Planning, Land Use and Mobility Committee

Case Report on: New Single Family Residence ZA-2017-1883-ZAD-SPP-MSP 4306 N. Camello Rd. Woodland Hills, 91364

PLUM Present: August 17, 2017

West façade (Front) facing Camello showing proposed materials

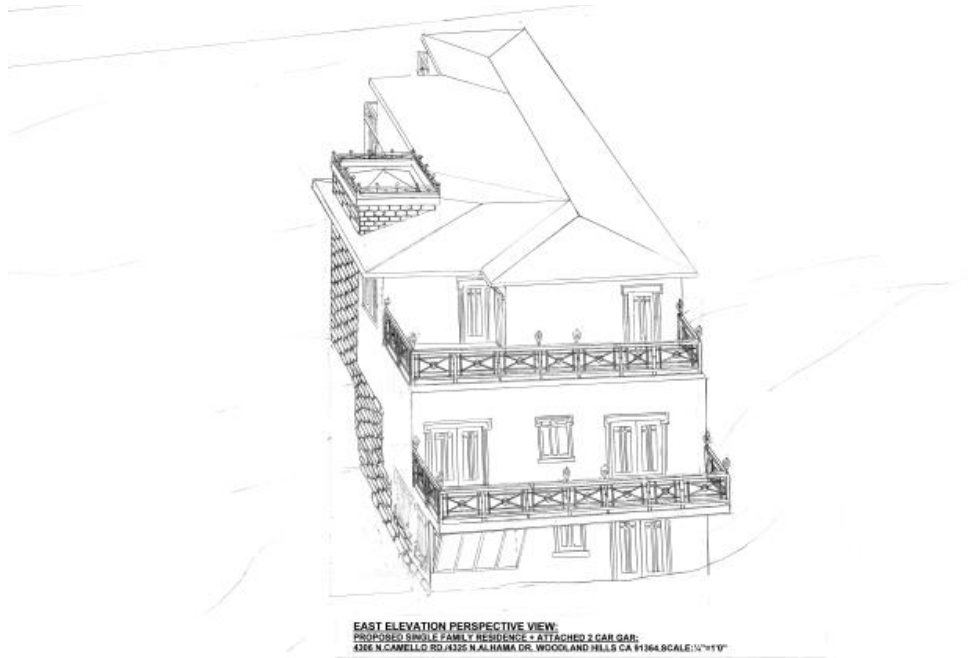
- “Oatmeal” color stucco deemed too light for color palette.
 - Architect’s color choice taken from MSP color palette, but was requested to choose a darker color.

- Stone/brick elevator column on southwest corner of structure is too massive and lacks articulation.
 - Architect to update plans and submit new renderings to MDRB.

- Was suggested that planter boxes could be added to the base.
- Composition roof is “acceptable” but MDRB thought it was not in keeping with upgraded building materials and finishes used elsewhere on project.

- MDRB suggested using a barrel tile roof.
 - Architect to present new roofing alternatives
- Rear elevation (east) of the structure lacks articulation and is too massive. Also, may be too high.

- Addition of 5’ retaining wall and gravel apron along toe of hill abutting Alhama.
- Revised materials to have permeable pavers with grass in-between stones.
- Added steel supports for front balcony.
- Architecture height now conforms to MDRB guidelines and parallels slope of hill.
- Has obtained soils approval documentation
- Investigating change of roofing materials to lightweight concrete/slate.
- Color changes to slightly darker MDRB recommended shade.
- Landscape plan now utilizes deep-rooted plants and additional native, drought-resistant trees (15-30 gal) for soil retention. Existing Oak tree to be retained. All new plants to have roots in mesh baskets to deter gophers.
- Jute mesh on hillside to hold initial plantings will disintegrate after two years after plants take hold.

View showing rear (east) elevation and side (south).

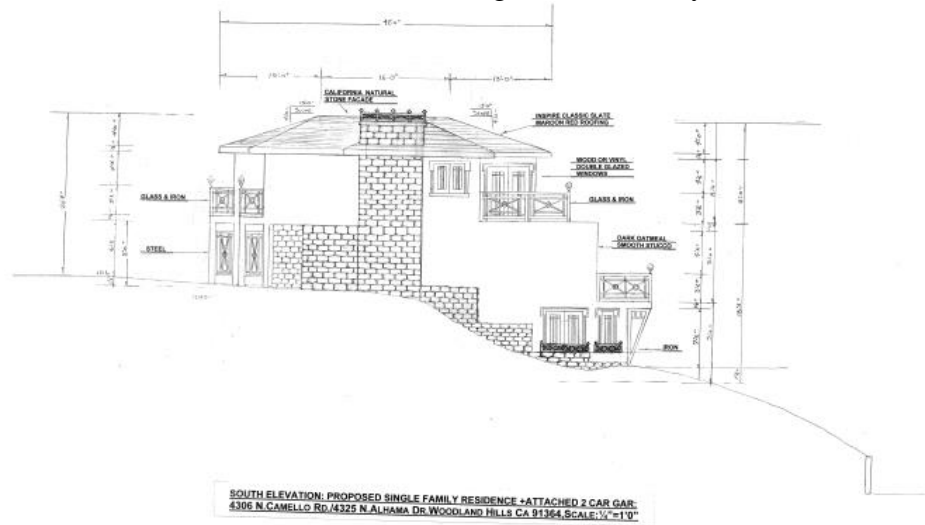
- Applicant to present a composite plan for elevation that features structure on hillside showing natural and cut elevations with measurements for structure to determine if it is within maximum permitted heights based on the lowest of natural or cut grade.

- MDRB stated they require a single page showing height configurations and terrain elevations.
 - MDRB was not specific as to massing but requested architect to reread regulations and make adjustments.

Taken from ZIMAS 2011 Aerial picture background, this shows that the bush/trees and some hillside soil are in the street right-of-way narrowing the street to under 20 ft. wide.

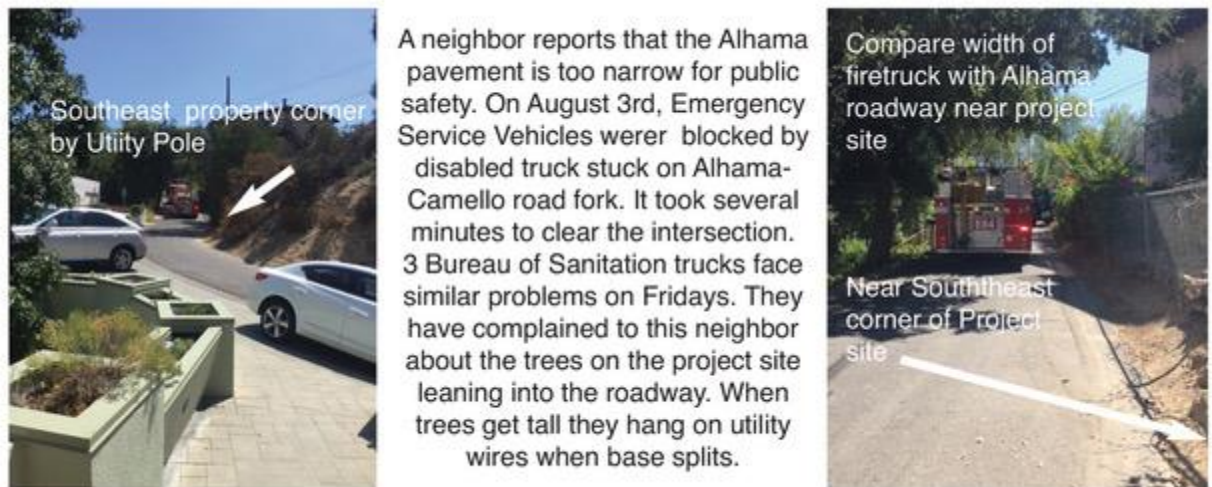
1. Significant amounts of hillside soil from the lot are constantly washed down onto the already confined Alhama roadway. The sloughage and debris increasingly extends the "toe" of the hill well beyond the property line and covers existing asphalt in the right-of-way. The residual soil on the roadway does not include the portion that is washed downstream during high runoff flows which travel downstream to pile up at a low point near the golf course affecting many residents requiring removal by street services of several inches of mud blocking Rios Street.
2. Large "scrub" trees have taken root in parts of the vacant lot and are intruding into the Alhama roadway where cars and service vehicles

3. The lack of hill retention and proper drainage system for the base of property along Alhama is causing issue #1. Soil sloughing from rodents and water runoff during rains which carry mud and debris onto the Alhama Dr. roadway and parts beyond. This is a common problem in the hillside area.

4. City maintenance crews do not monitor hillside streets for removal dirt and debris unless called by homeowners by the golf course.
5. Alhama needs to be widened at the toe of the slope back to its original property line boundary because narrow width is hampering access for Sanitation, LAPD and LAFD emergency vehicles.

- 1.) Applicant will remove up hillside to 1 foot inside the property line, plus all soil and debris that has run off or eroded from his lot along the eastern border onto Alhama Drive and restore the roadway to the edge of the public right-of-way.

- 2.) Applicant to construct a retaining wall or install some other soils retention system at the toe of the hill 1 ft. inside the property line adjacent to the Alhama roadbed insuring that soil and leaf litter from the slope due to precipitation or animal activity no longer flows onto the widened roadbed and allows for clearance of city paving equipment. The City to pave Alhama Dr. up to property line with an asphalt berm in the retention wall setback along right-of-way.

Proposed landscape plan showing 5' retaining wall and gravel edge along Alhama on East and added trees and shrubs on slope.

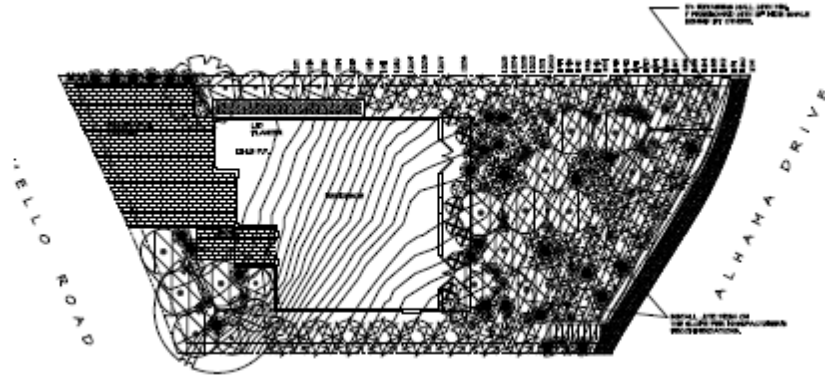
- A retaining wall or some hill retention system of suitable design to the MDRB must be put in place by the Applicant insuring soil and leaf litter from the slope no longer creep onto the restored/widened Alhama roadway.

- A rainwater/groundwater dispersal system (including a swale system if necessary) needs to be placed on the hillside and at the hill retention wall along the toe of the slope to collect all rain water and ground water, and conduct it without particulate matter over the Alhama roadway berm/curb onto the pavement. The purpose is to prevent hillside slippage, soil sloughing and water runoff/accumulation that weakens the integrity of the hillside.

- All existing “scrub” trees and bushes on the property intruding over the Alhama Dr. right-of-way and affecting traffic and utilities should be removed.
- The submitted landscape plan calls for installing jute mesh on the back hillside slope and planting the majority of the slope with Yankee Point Ceanothus. While acceptable, the hillside slope needs plantings of shrubs and trees with much larger and deeper root systems in order to hold any potentially eroding soil.

- There is a lack of any significant tree specimens being planted on the north, south or east sides of the property. It is understandable that the Applicant wants to preserve maximum views from their proposed balconies, however this lot is in a heavily wooded area and the lack of significant trees is a negative in helping the project fit into the existing neighborhood and preserve a natural ridgeline. Several larger tree specimens should be considered for the downhill sides of the slope.
- The proposed paver choice for the driveway and front parking/walkway areas is a positive. However, there is a need to make the pavers more permeable.
- The irrigation system must have some form of “catch system” so that water does not accumulate at the base of the hill and can be safely conducted without particulate matter to the adjacent roadway pavement.

- 3.) That a water dispersal system be placed along the top and base of the soil retaining structure to collect and filter all rain water and ground water, and conduct it to the roadway so that it does not weaken the integrity of the hill.

- 7.) Excessive height concerns should be determined by the MDRB and mitigated if necessary.
- 8.) Hillside slope should have plantings of shrubs with large and deep root systems than those shown on the initial submitted landscape plan in order to hold any potentially eroding soil.
